Agenda
City of Springboro Planning Commission Meeting
Wednesday, February 8, 2023, 6:00 p.m.
Council Chambers, City Building, 320 West Central Avenue

- A. Final Approval**
Preliminary Subdivision Review, Wade-Wray property, Wadestone subdivision, 2515 Factory Road, residential subdivision.
- B. Final Approval**
Revision to Approved General Plan, Swope-Hills property, Wadestone subdivision, 465 West Factory Road, residential subdivision.

Wadestone Sub-Division General Plans– 2023-01-18 Planning Review Comment Responses

TYPICAL DESIGNER HOMESITE DETAIL
MIN. LOT SIZE 7,750 SF
MIN. FINISHED BLD 1,600 SF
N.T.S.

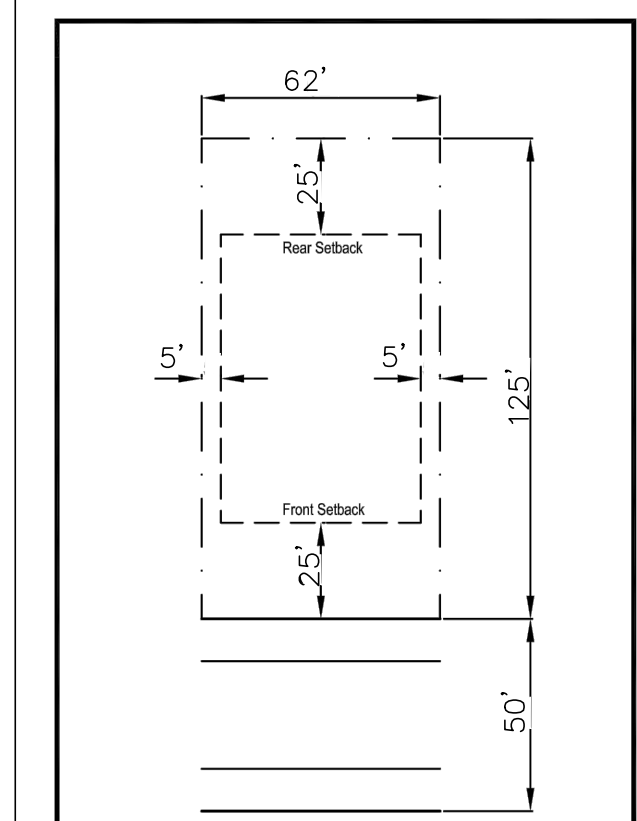
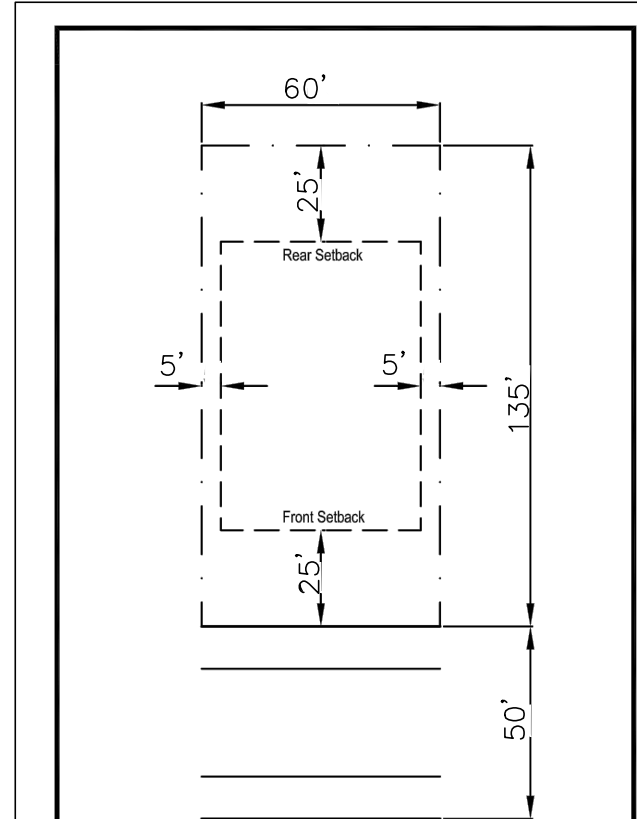
5. Provide minimum dwelling unit square footage for both house product types. Provide the product type details. **Minimum dwelling unit square footage has been provided as part of this final plan submission, product type details are shown on the plans.**

SHEET NO.: C-400

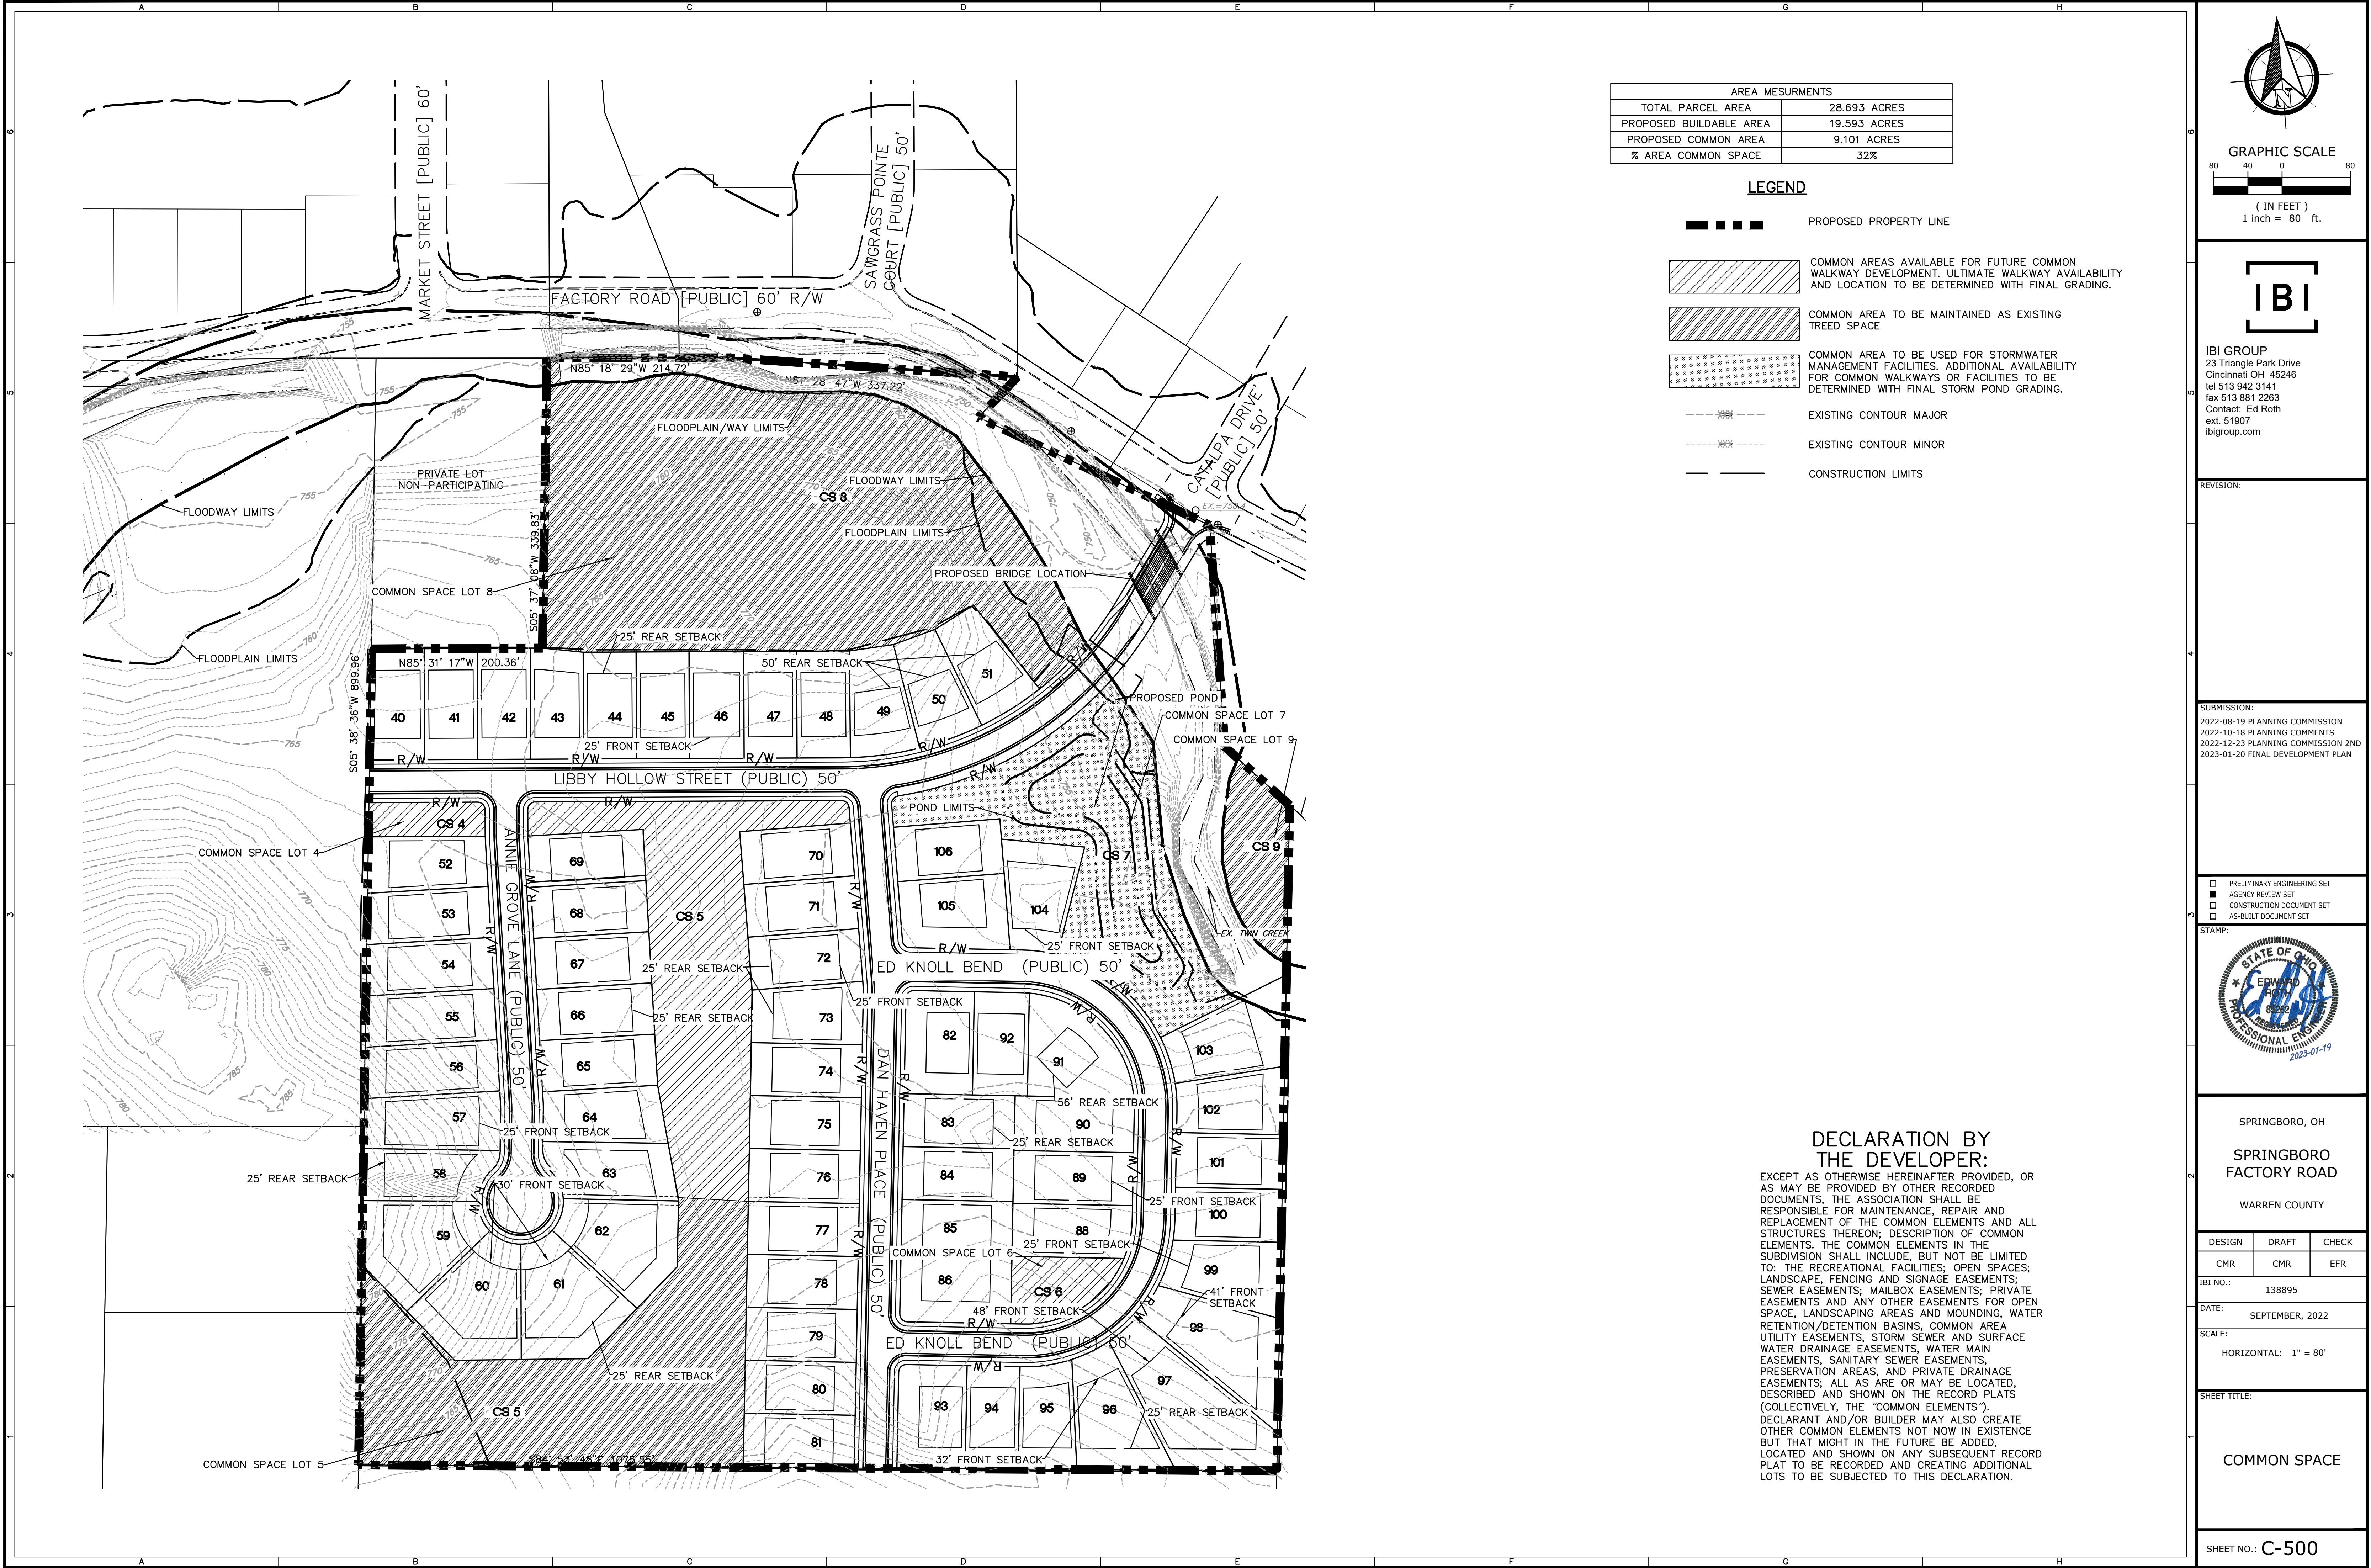
The proposed general plan show on sheet C-400 is largely unchanged from the October 12th submittal with respect to the plan details.

7. Homes that cannot be gravity drained by sewer shall not be permitted to have basements. Hung sewers and grinder pumps are not permitted. Remove buildable home area footprint for lot 103 to be outside of the Floodway. Development is not permitted in the Floodway. Adjust the setbacks accordingly. Adjust lot lines for lots 70 to 73 to make the rear yards for lot 72 & 73 standard 25 foot rear setback lots.

8. Homes that cannot be gravity drained by sewer shall not be permitted to have basements. Hung sewers and grinder pumps are not permitted. Remove buildable home area footprint for lot 103 to be outside of the Floodway. Development is not permitted in the Floodway. Adjust the setbacks accordingly. Adjust lot lines for lots 70 to 73 to make the rear yards for lot 72 & 73 standard 25 foot rear setback lots. **Setbacks have been updated to remove buildable area from floodway. Lots 70-73 have been revised to allow for a standard 25' rear yard setback.**

SHEET NO.: C-400

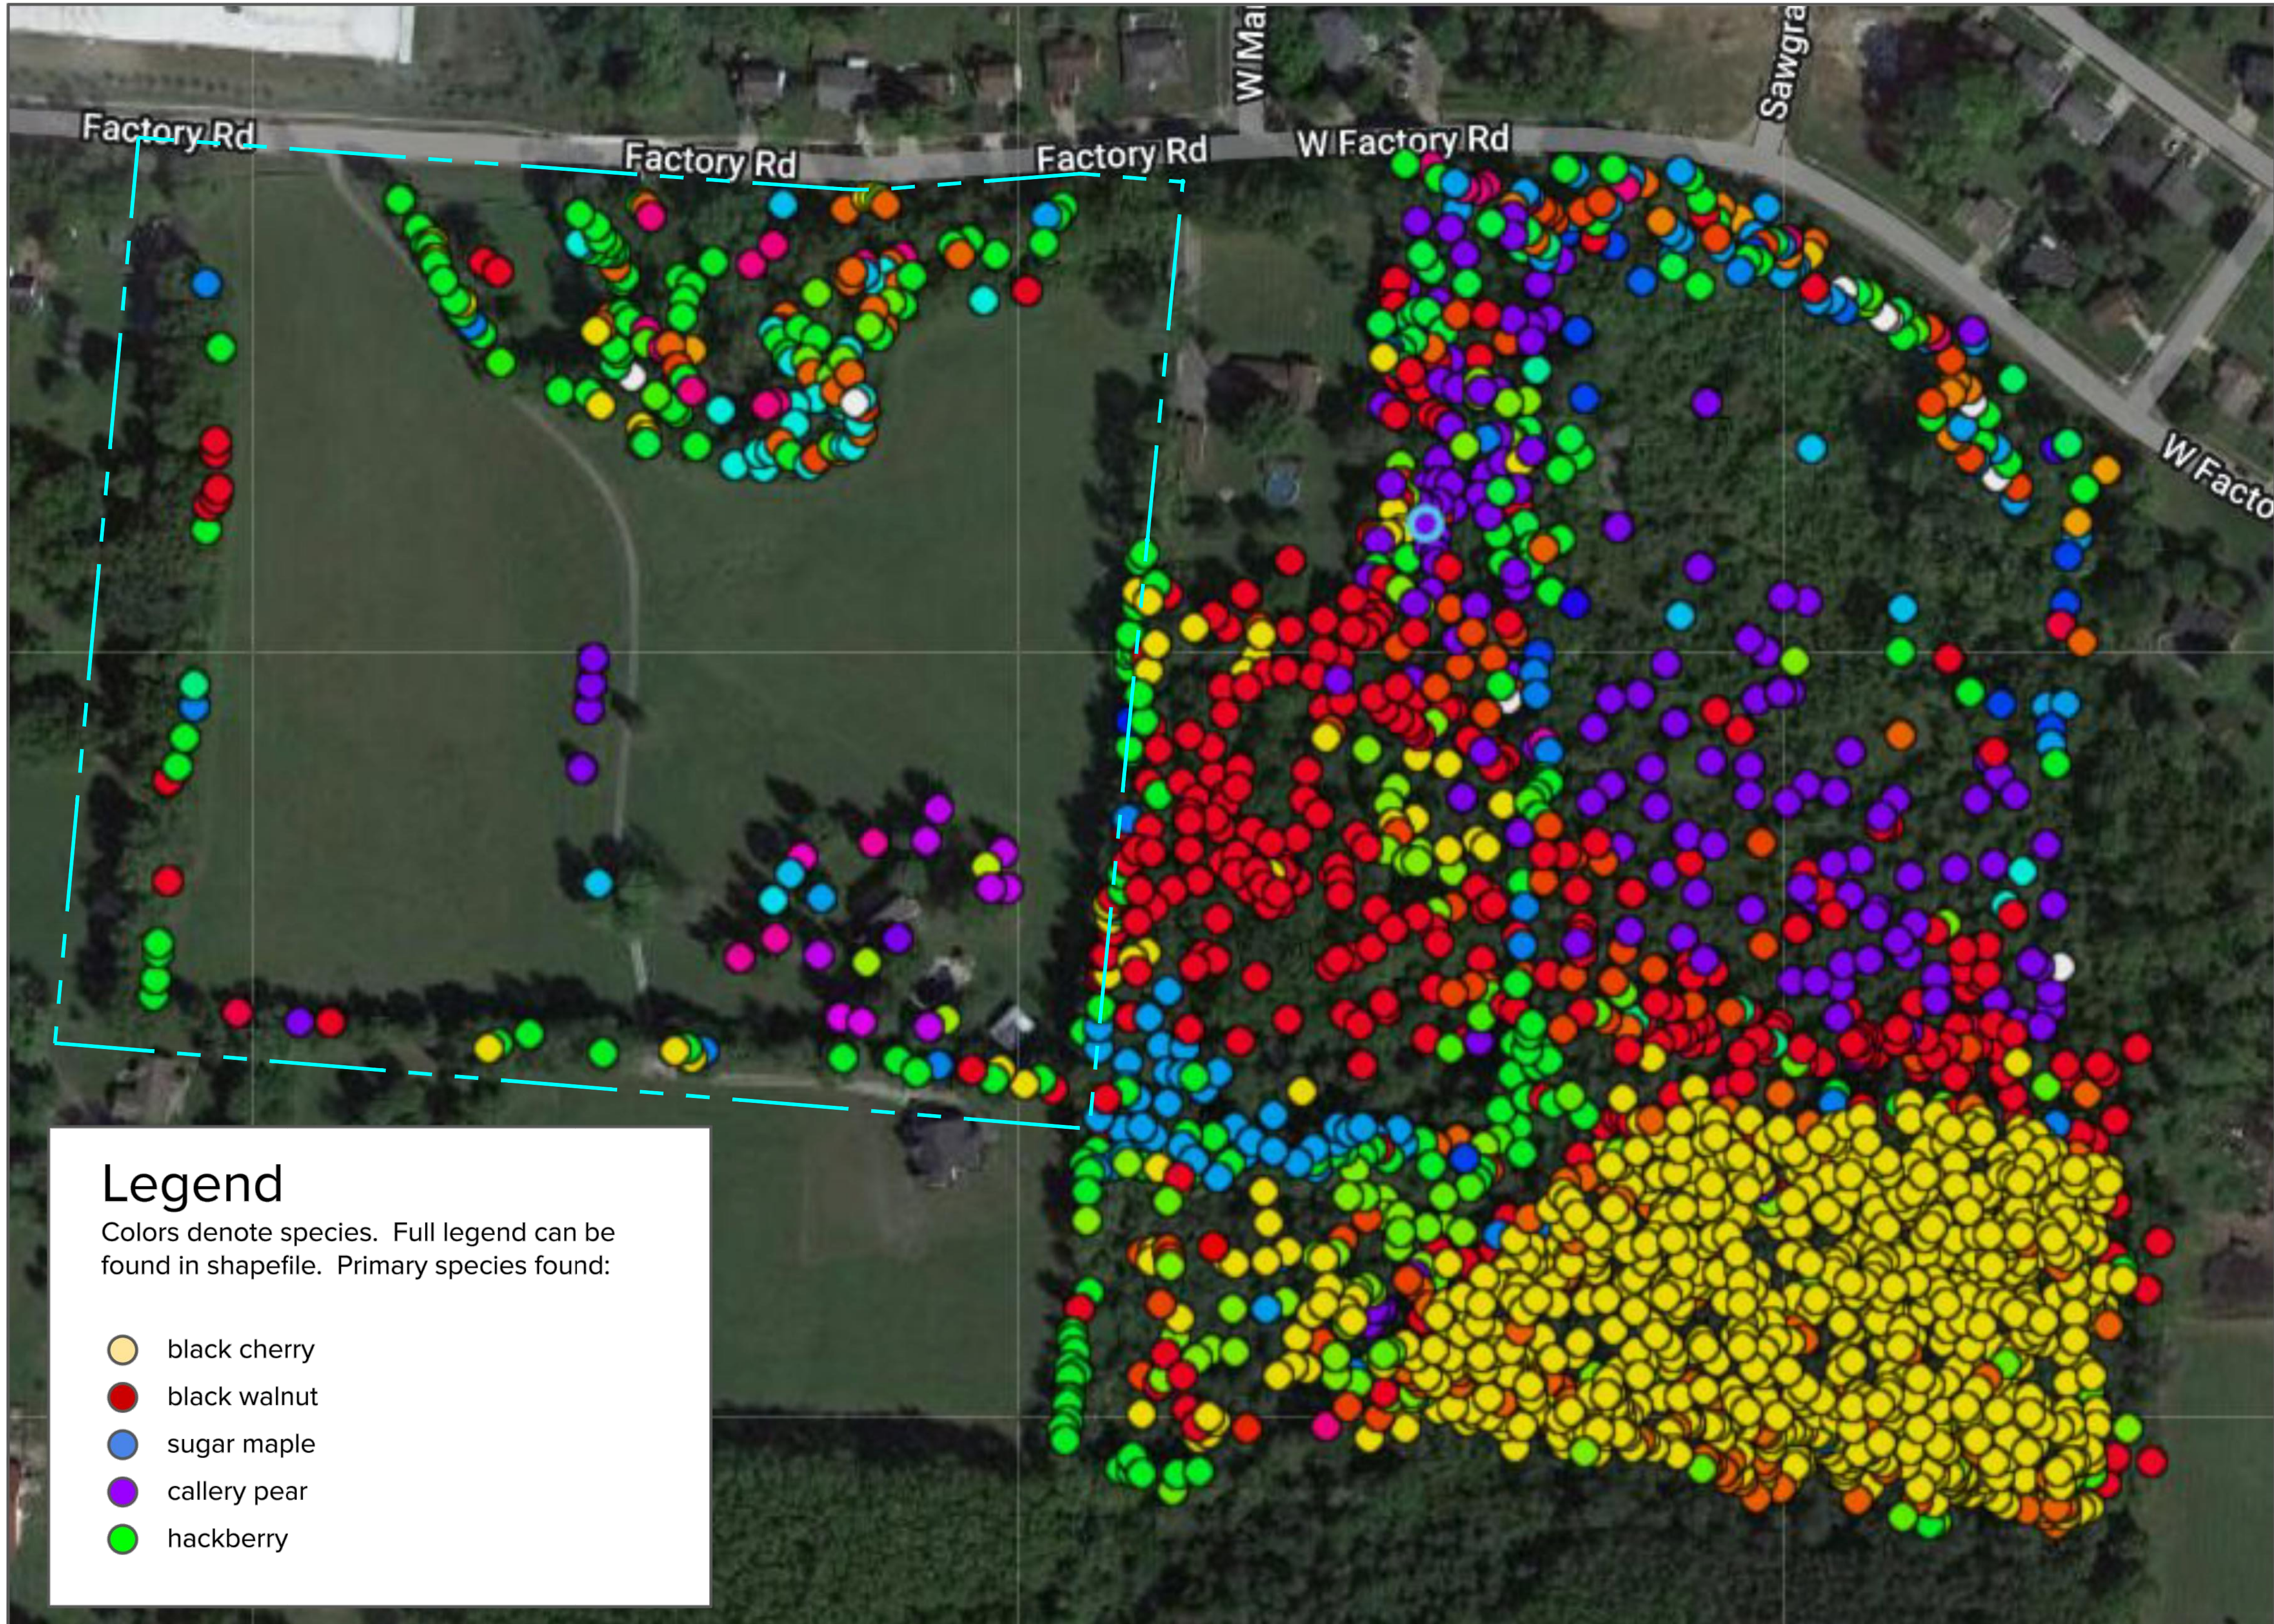
This property is located at 2515 West Factory Road, southwest of the intersection of West Factory Road and West Market Street. The naming of this property is to help in the explanation of the review and approval process only; the name is derived from the current property owners. The site is currently used as a farm and includes one single-family residence on its southeast corner. The property is approximately 19.68 acres in area, and is zoned R-1, Estate-Type Residential District, a zoning district that permits development at the rate of 2 units per acre. The R-1 District requirement a minimum lot size of 20,000 square feet. The R-1 District is a conventional zoning district. No open space is required as part of this property's development, however approximately 2.18 acres of open space, 11.08 percent of the site's acreage, is proposed in the plan. The preliminary plan shown on sheet C-400 is largely unchanged with respect to the plan details.

7. Development is not permitted in the floodway. Adjust setbacks accordingly.
8. A homeowner association (HOA) shall be created and recorded prior to the recording of the record plan. Submit HOA documents for review when ready. HOA shall be responsible for maintaining items such as, but not limited to, open space, landscaping, storm water facilities, entry monuments, sump drains, central mailbox units, etc.

7. Remove buildable home area footprint for lots 9 and 15 to be outside of the Floodway. Development is not permitted in the Floodway. Adjust the setbacks accordingly. **Setbacks have been updated to remove buildable area from floodway.**
